Development Services Staff Report

File Number	PL2026-002
File Name	REZONING from CP-2 to CS and PRELIMINARY DEVELOPMENT PLAN – Shamrock Park Flex Space
Applicant	Engineering Solutions, LLC
Property Address	21 SE 30 th Street
Planning Commission Date	March 12, 2026
Heard by	Planning Commission and City Council
Analyst	Adair Bright, AICP, Senior Planner

Figure 3 – West elevation facing Old 291 Hwy.

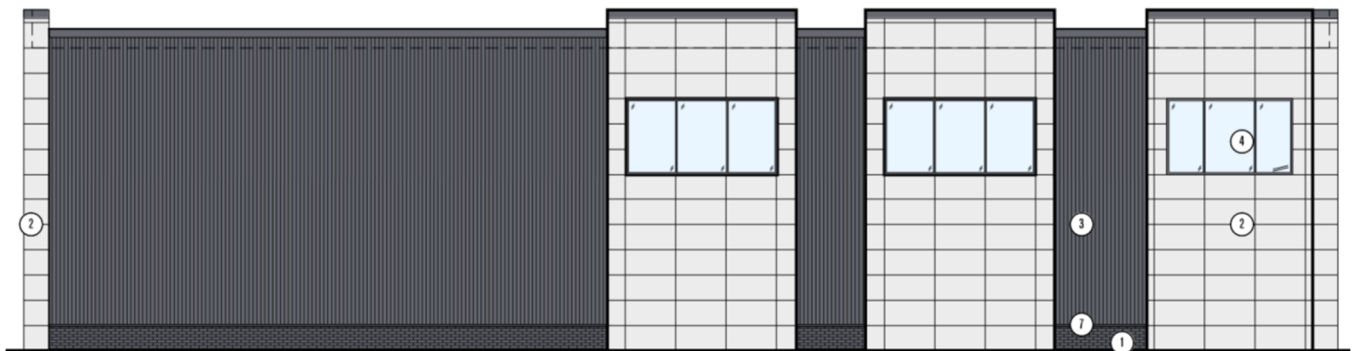
From an architectural standpoint, the proposed development is not expected to negatively affect the aesthetics of neighboring properties as the building uses high quality, durable materials. The UDO was recently amended in August of 2025 to include more detailed architectural and building design requirements. The proposed building meets all requirements, and the building form is compatible with adjacent existing developments.
